McNICHOLS® PERFORATED METAL

DWG NUMBER	REVISION
18335316	A

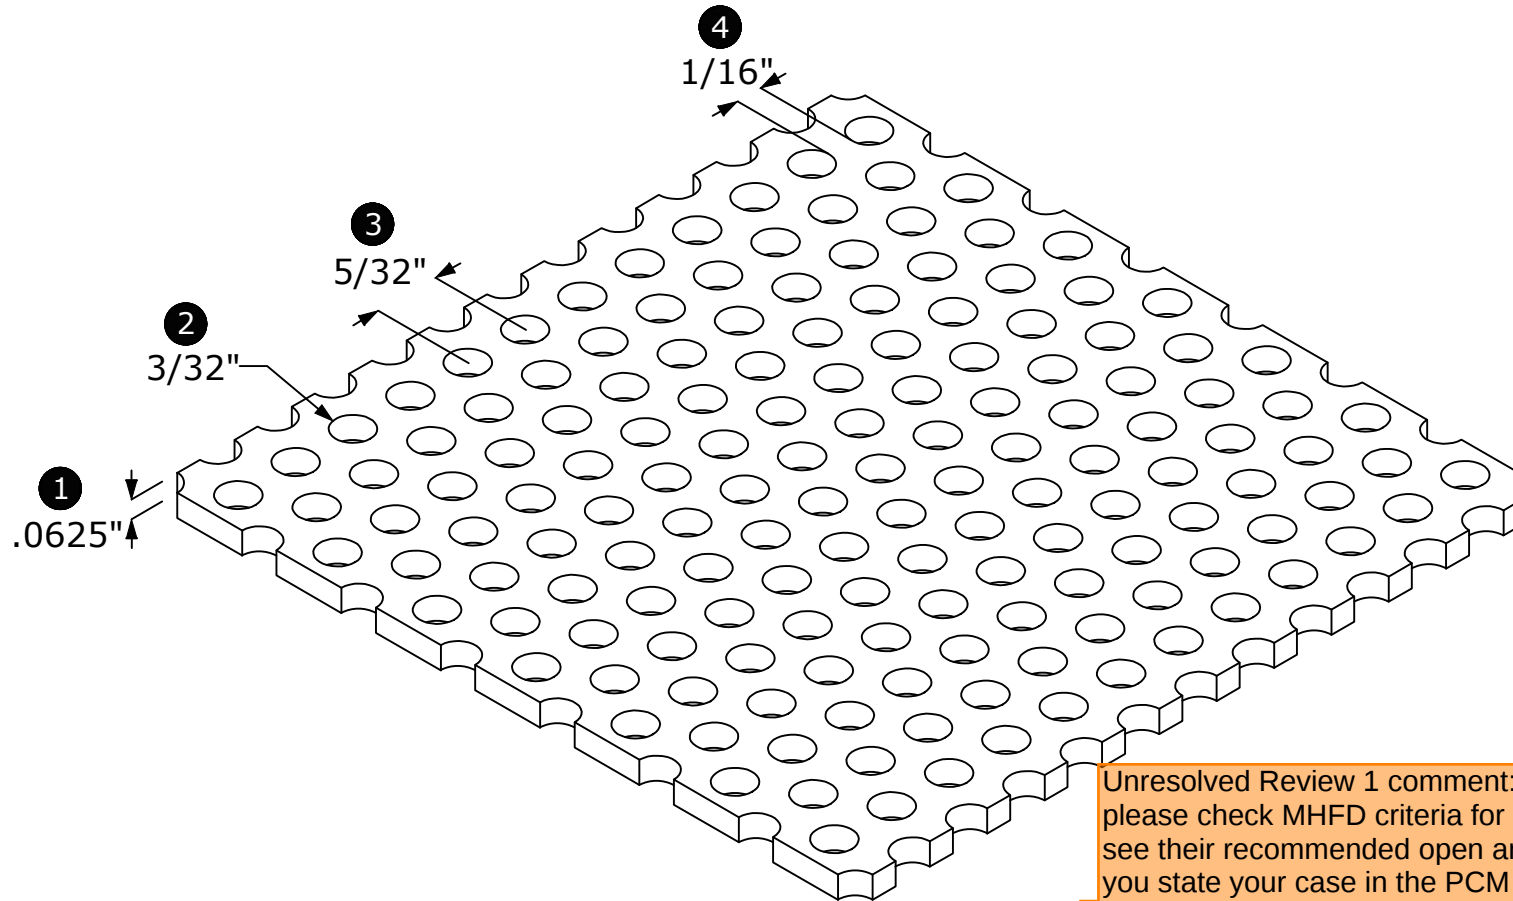
Unresolved Review 1 comment:
please check MHFD criteria for microscreens to see their recommended open area. That will help you state your case in the PCM Cert Letter as to how this is an acceptable alternative. Likewise, find the open area of the vee wire on the original design to show how this is an equivalent alternative to that.
